Addendum No. 3
May 18, 2023

Prosser Hamilton Lab Bldg Roof Replacement
Washington State University
Prosser, WA

Project No.1933-2023
Washington State University
Facilities Services, Capital

A103

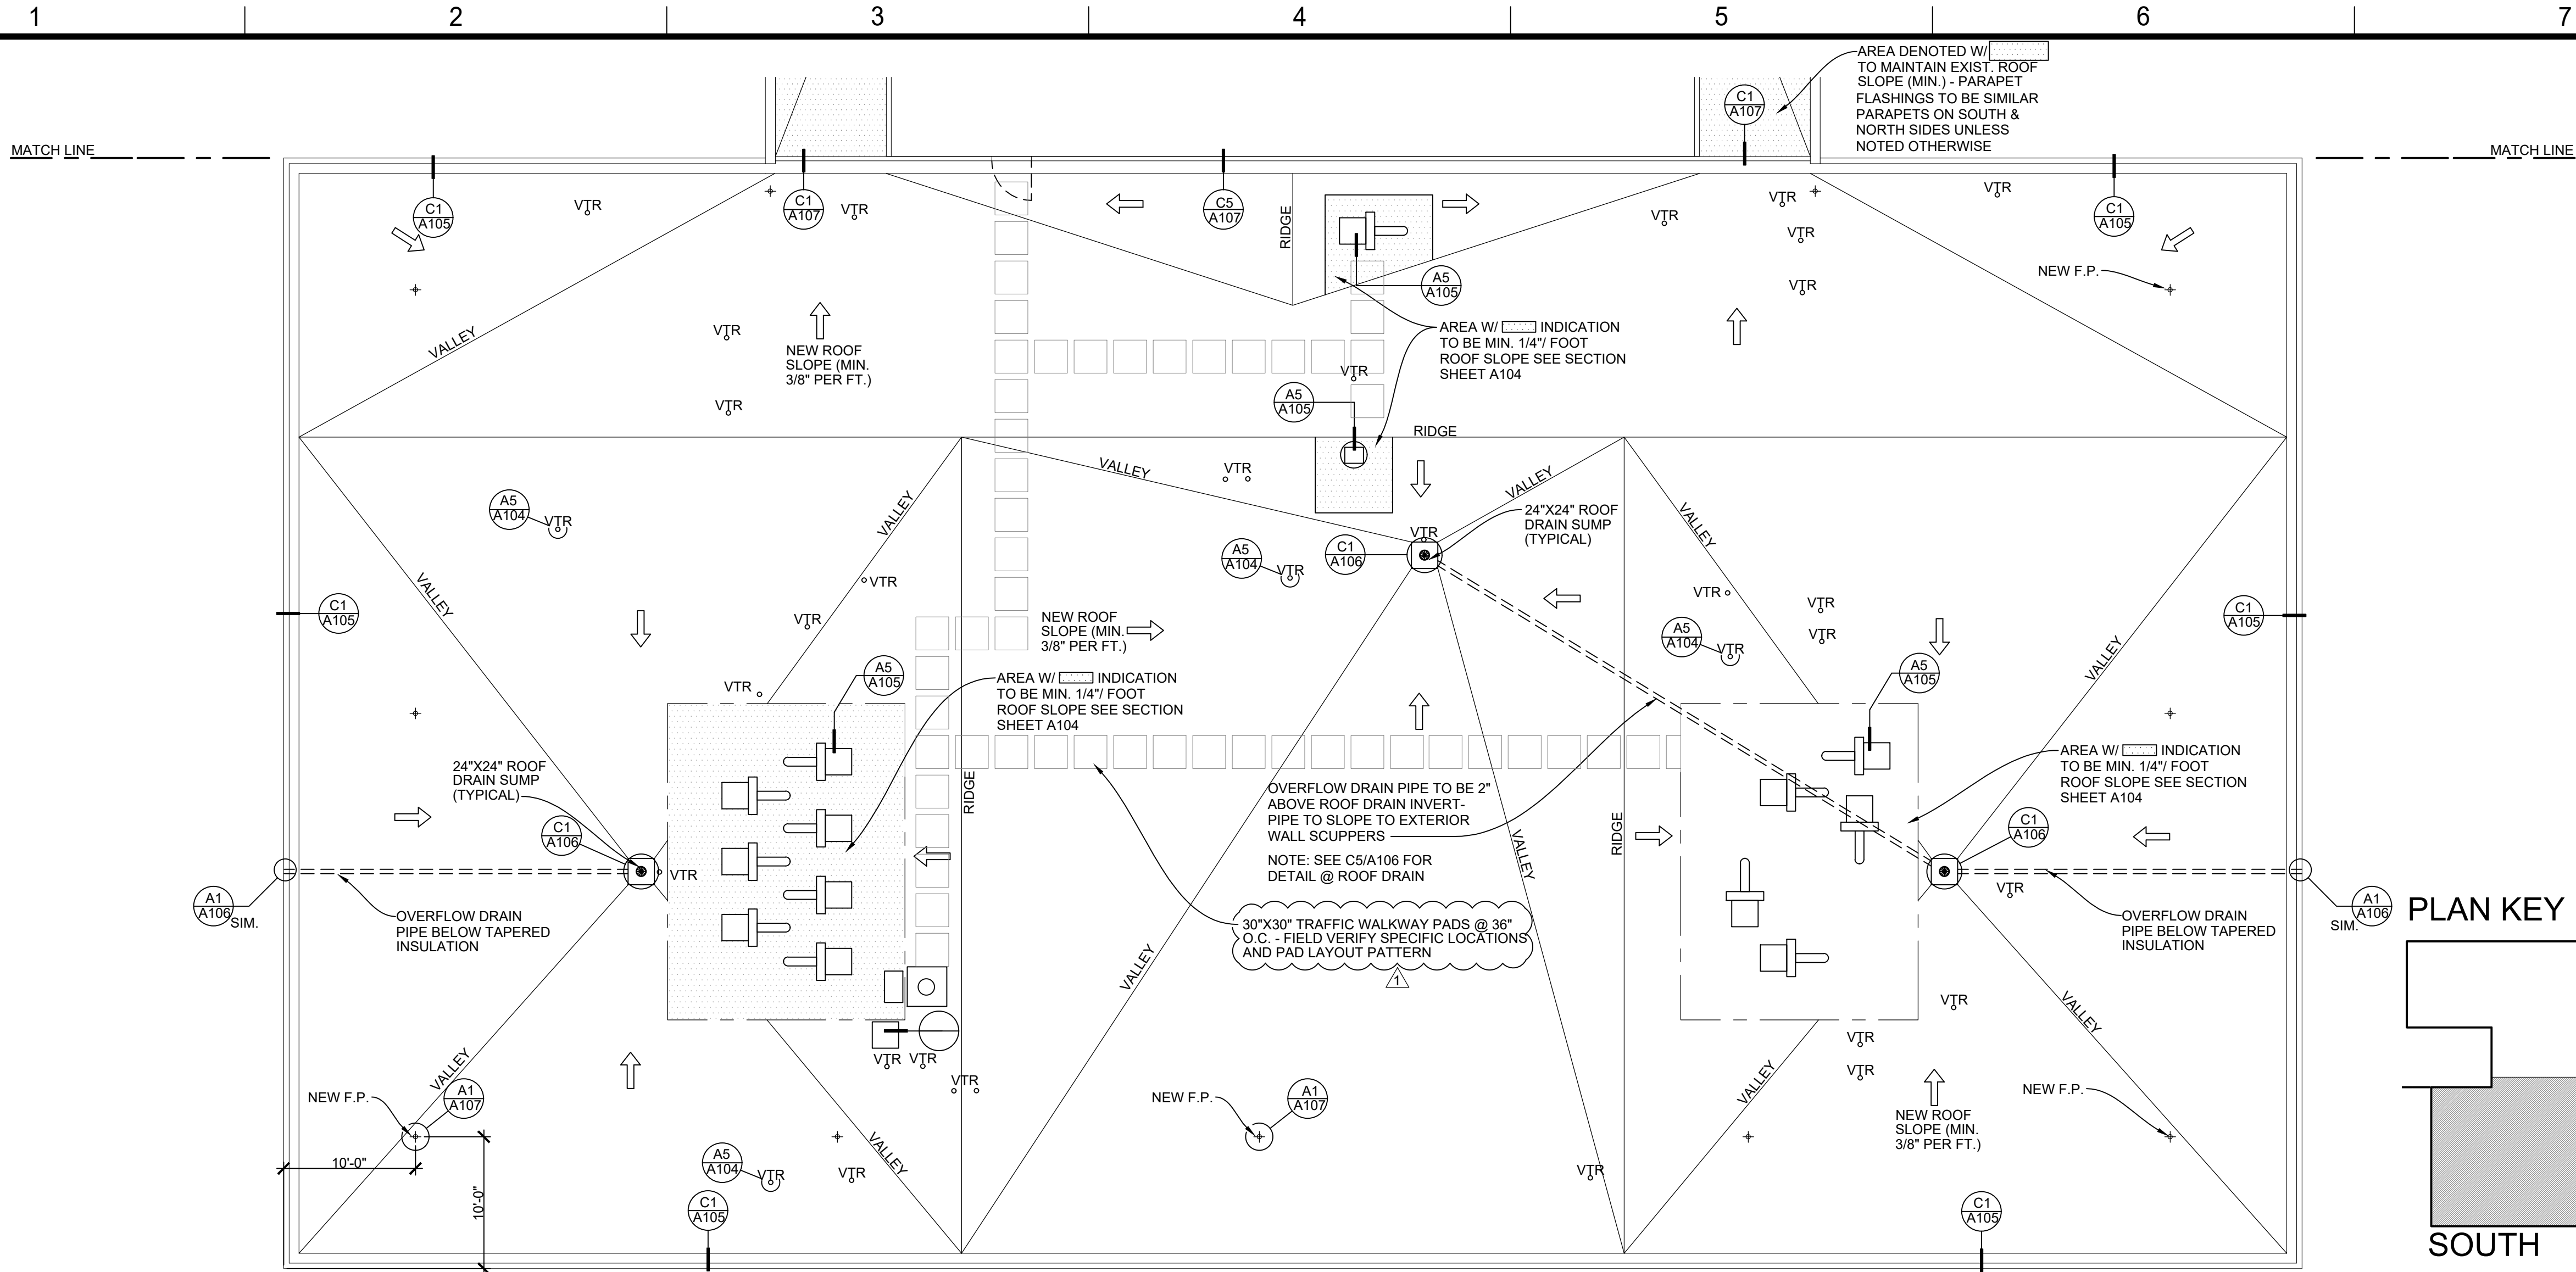
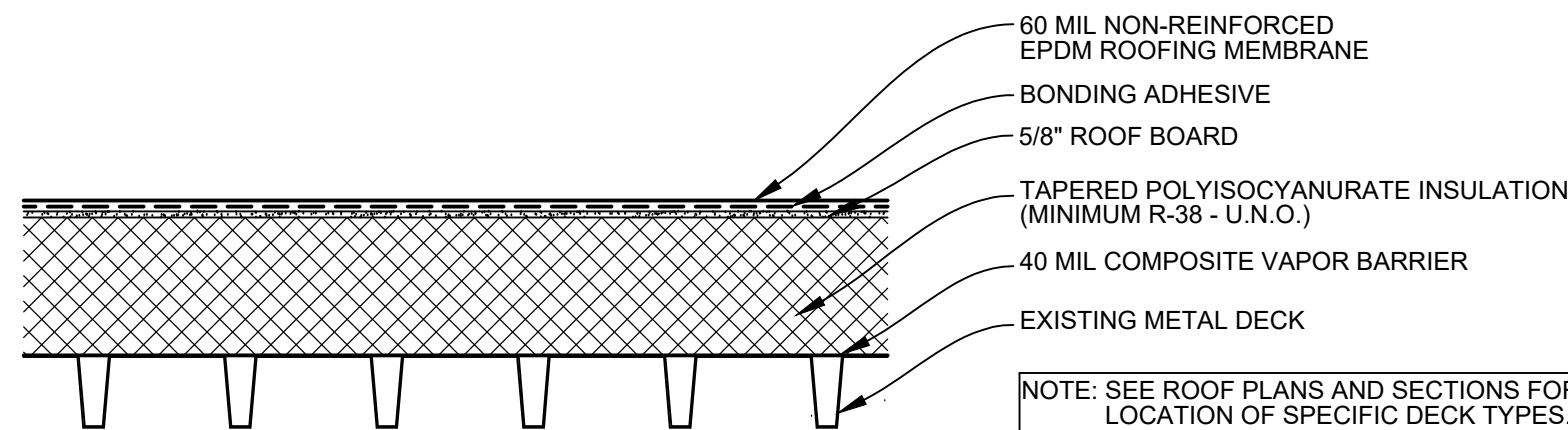
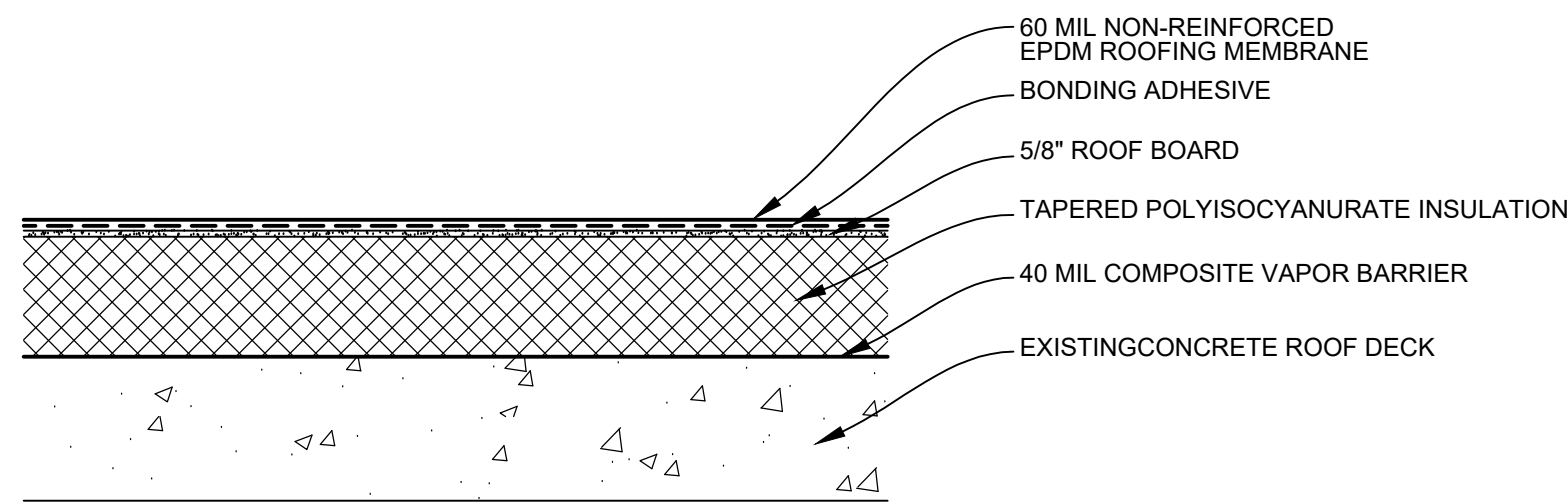
DWG 1-1. Drawing A103 Roof Plan South/Notes

Item 1. Add A103 Roof Plan South/Notes

OVERFLOW PIPE REVISION

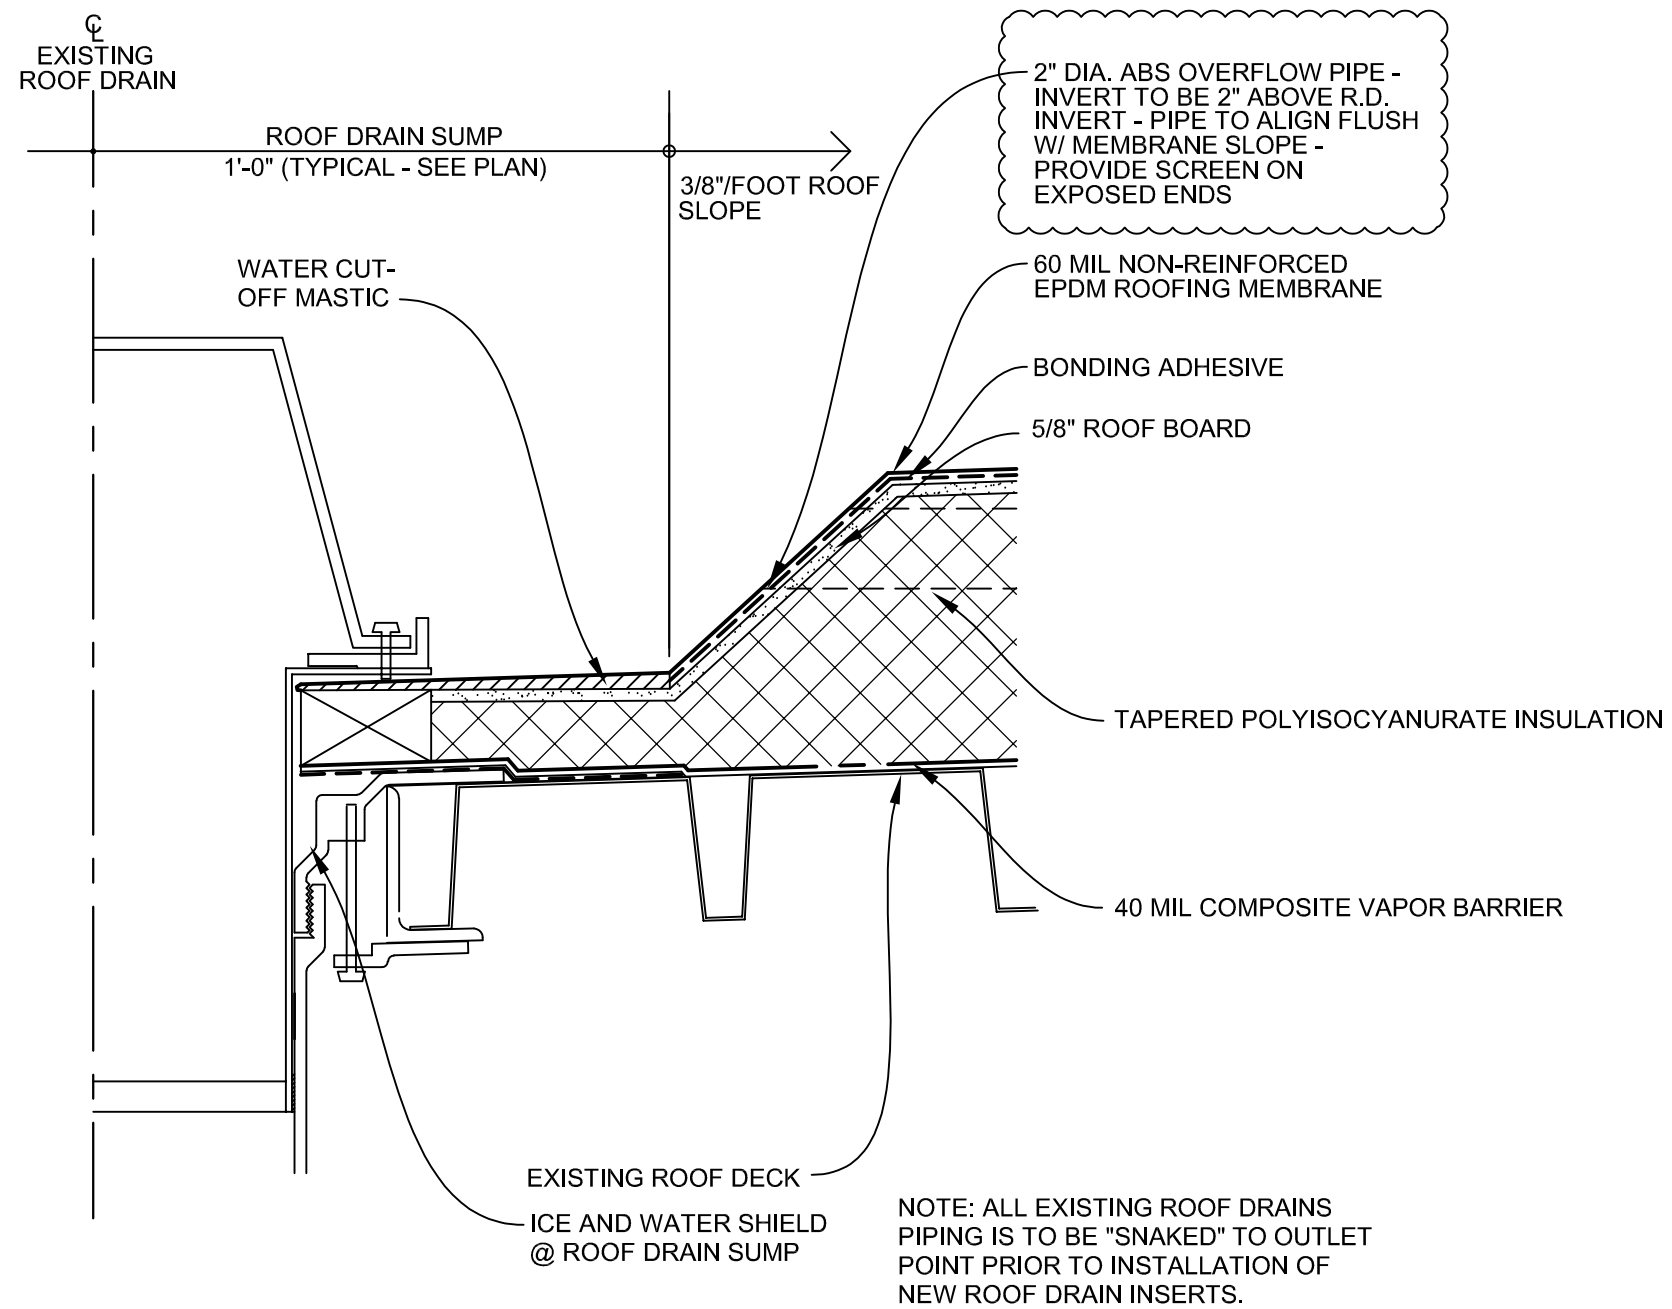
DWG 1-2. Drawing R-1 Overflow Pipe Revision.

Item 1. Add R-1 Overflow Pipe Revision.
